PCN - Process Change Notification

Change:	A.40.A.301111
Date:	2016/06/29
Author	Annie Nien

Model#	Part Number	Changes
Hercules Straight Screwmount	A.40.A.301111	Amend Label, Tolerance, Bom.
GPS/GLONASS 3M SMA(M) RG174

Illustration of Change

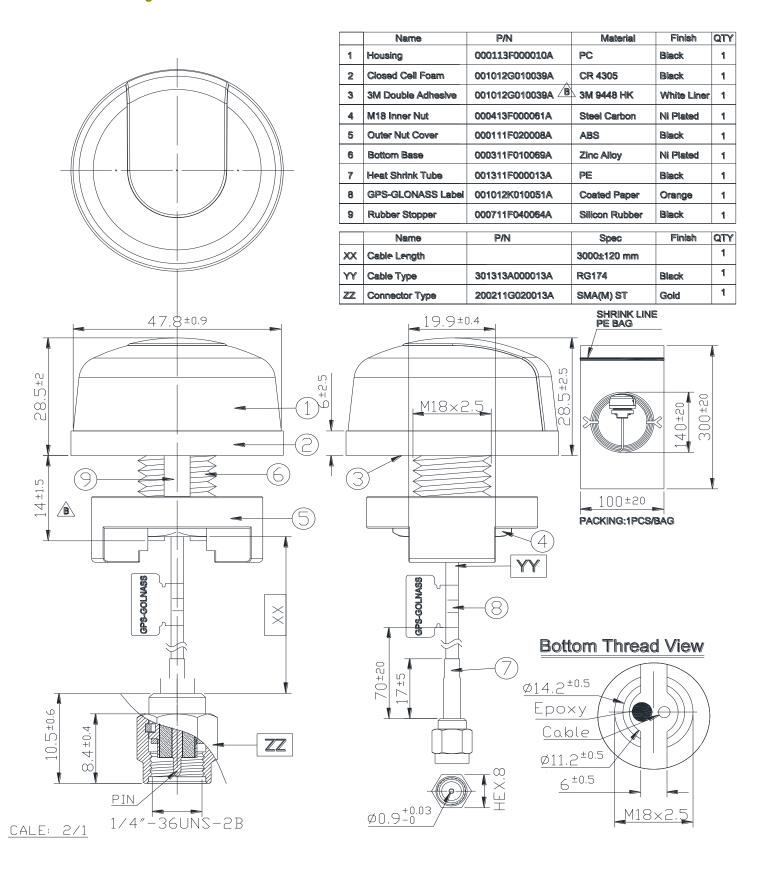
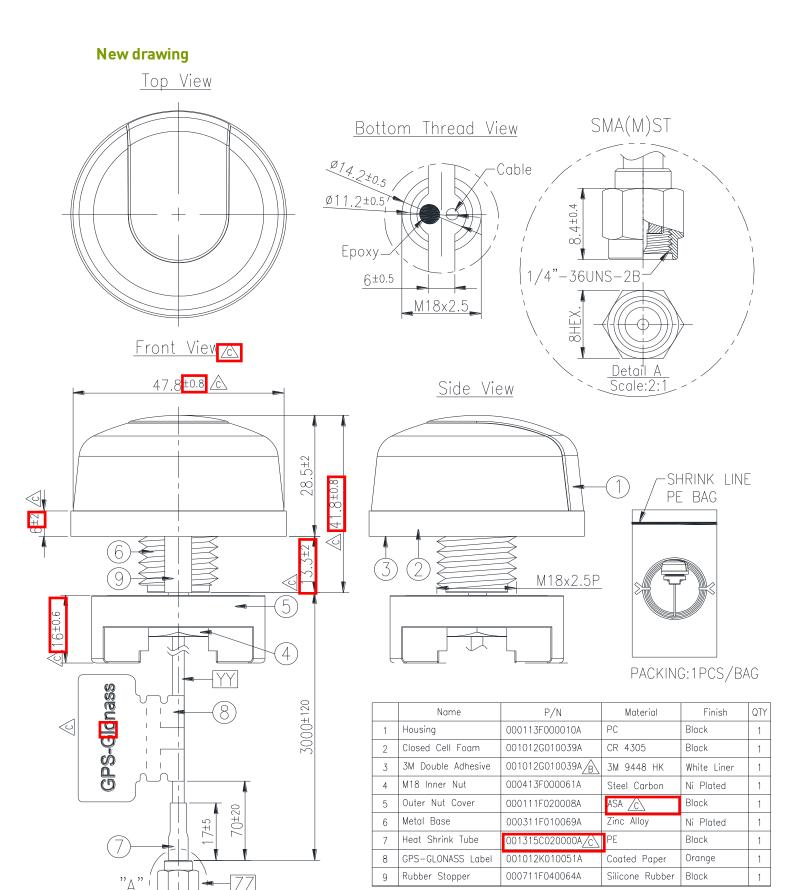
- 1. Amend printed text of GPS-GLONASS Label. It should be "GLONASS" instead of GOLNASS.
- 2. Changing the marking position and tolerance.
- 3. Amend Material of outer nut cover
- 4. Amend Part No. of Heat Shrink Tube, Cable, and Connector.
